## Permit Set

PROJECT:  
Commerce Bank

### New Atm Facility

160 NW Oldham Parkway Lees  
Summit Missouri

# C1.0

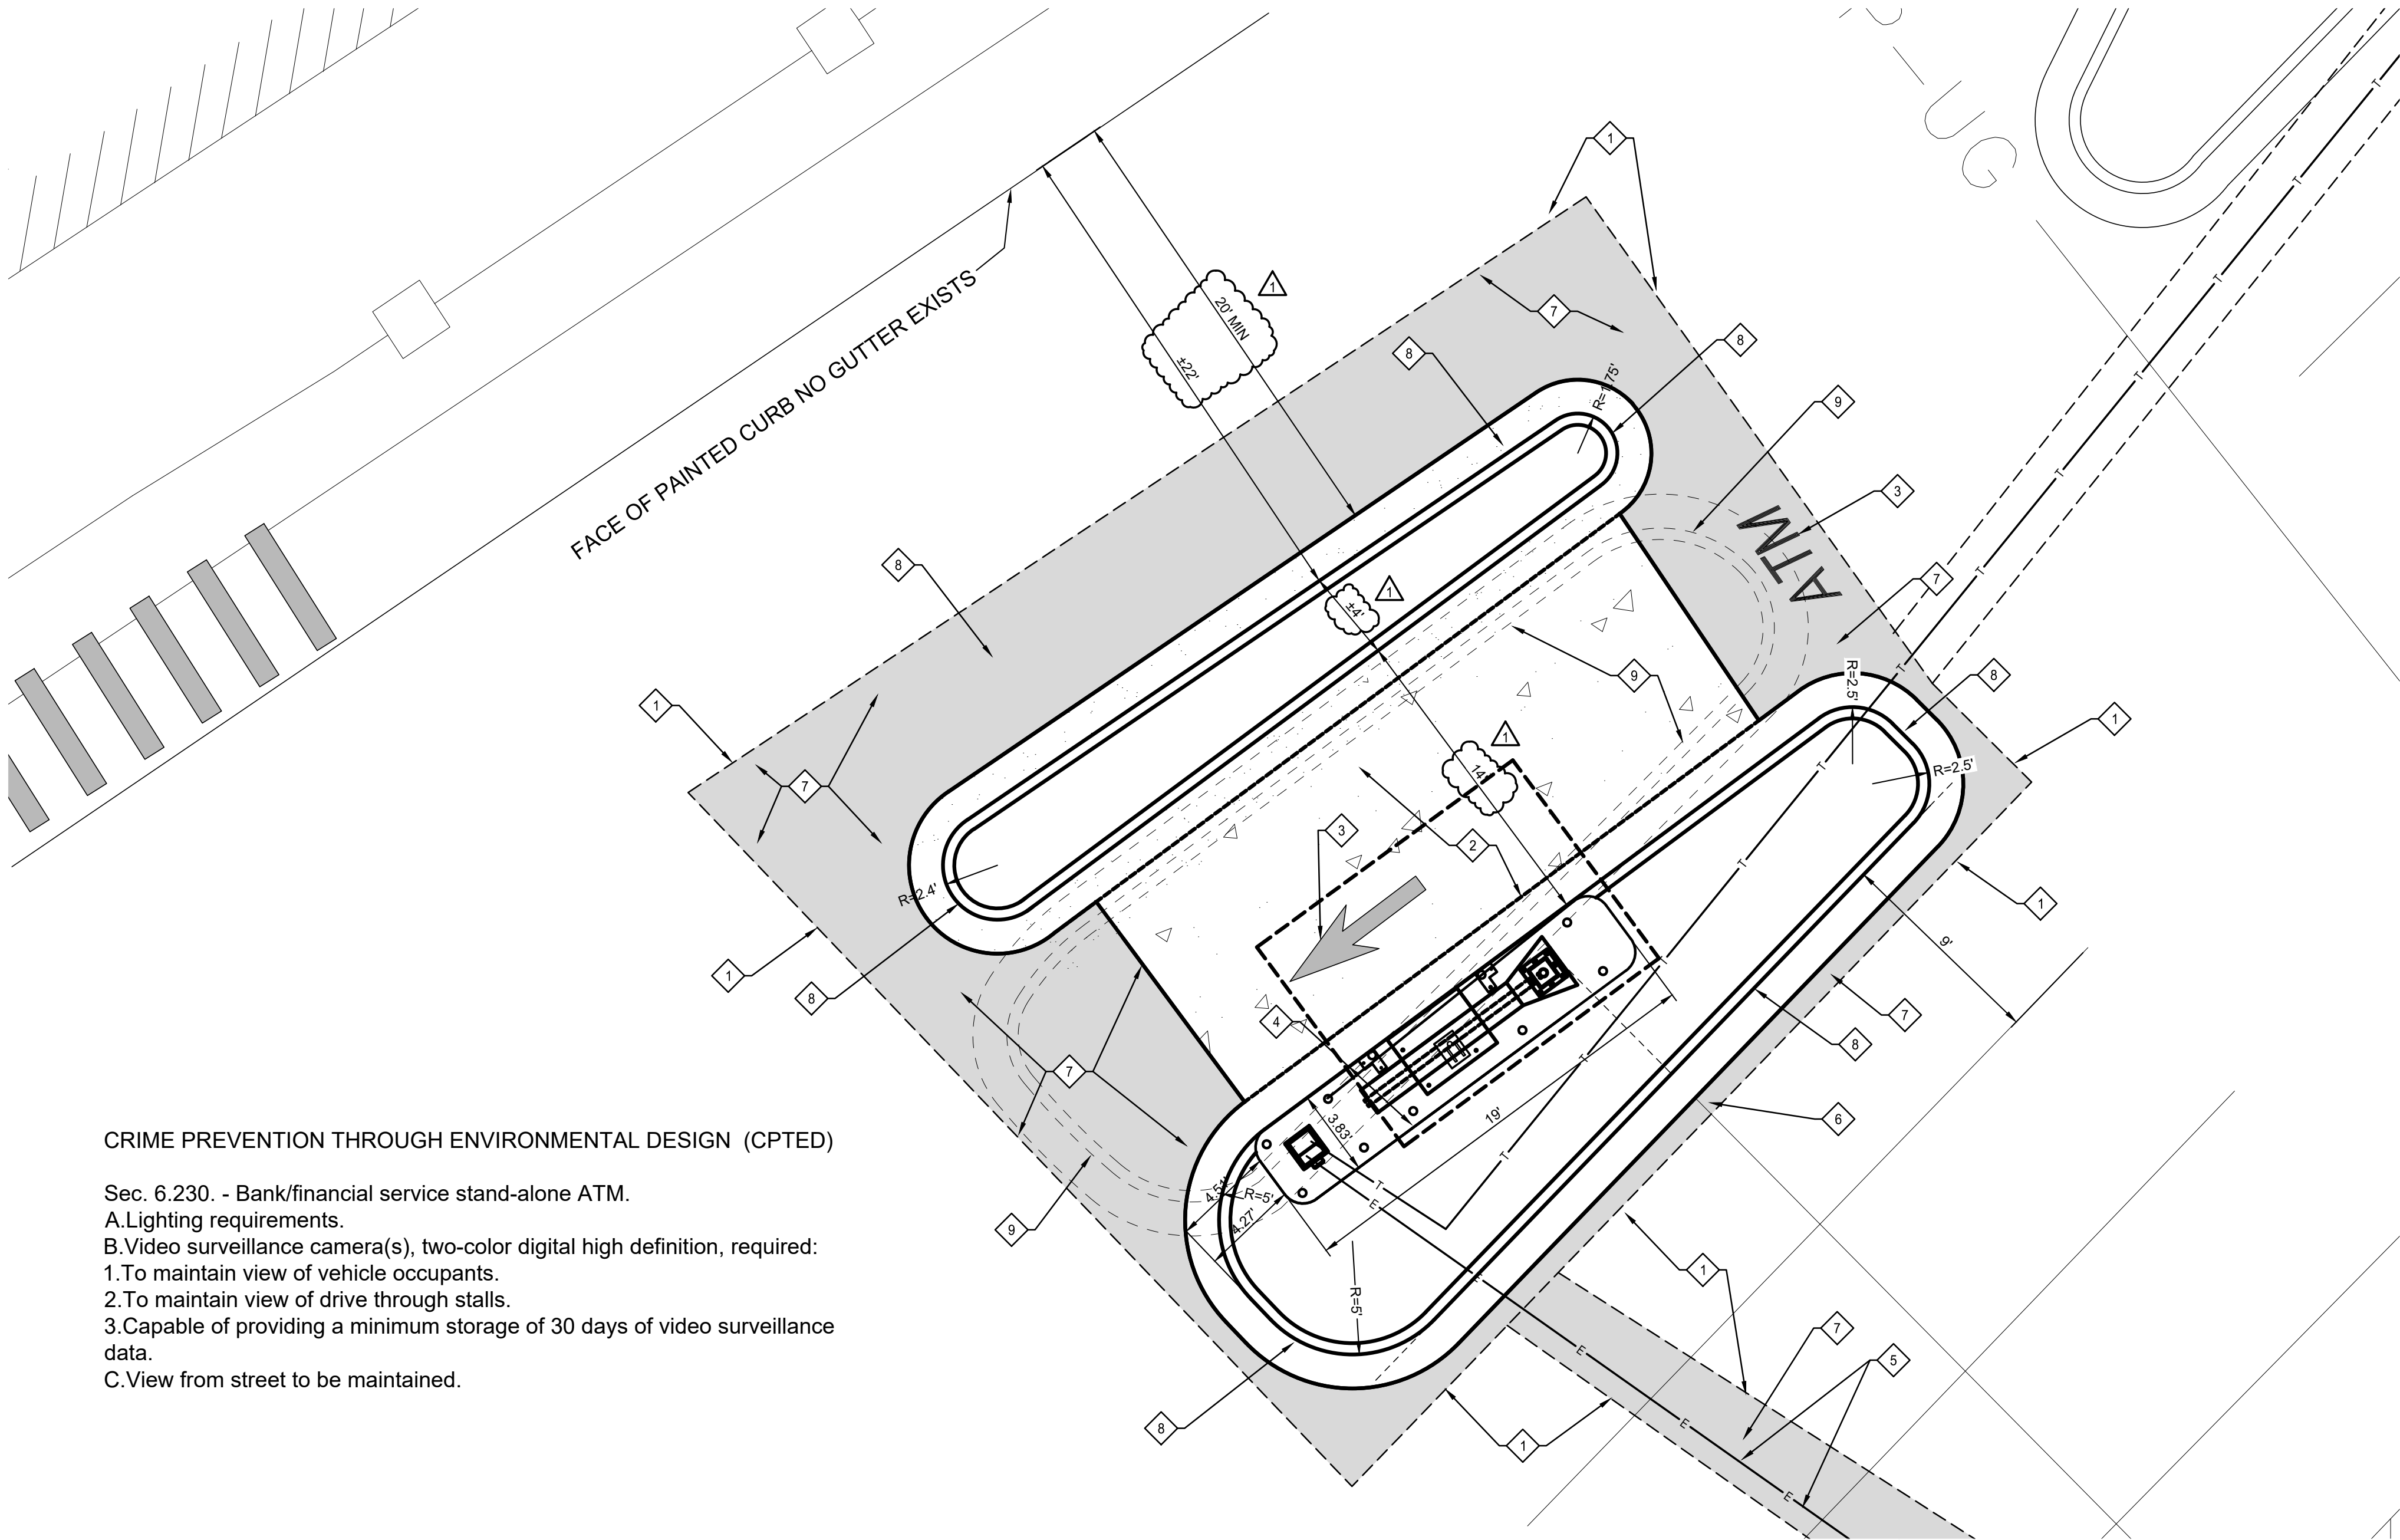
3. 2018 IBC 502.1 Address identification. New and existing buildings shall be provided with approved address identification.

The address identification shall be legible and placed in a position that is visible from the street or road fronting the property. Address identification characters shall contrast with their background. Address numbers shall be Arabic numbers or alphabetical letters. Numbers shall not be spelled out. Each character shall be a minimum of 4 inches high with a minimum stroke width of 1/8 inch. Where required by the fire code official, address identification shall be provided in additional approved locations to facilitate emergency response. Where access is by means of a private road and the building address cannot be viewed from the public way, a monument, pole or other approved sign or means shall be used to identify the structure. Address identification shall be maintained.

Action required: This site has been assigned the address of 160 NW Oldham Pkwy.
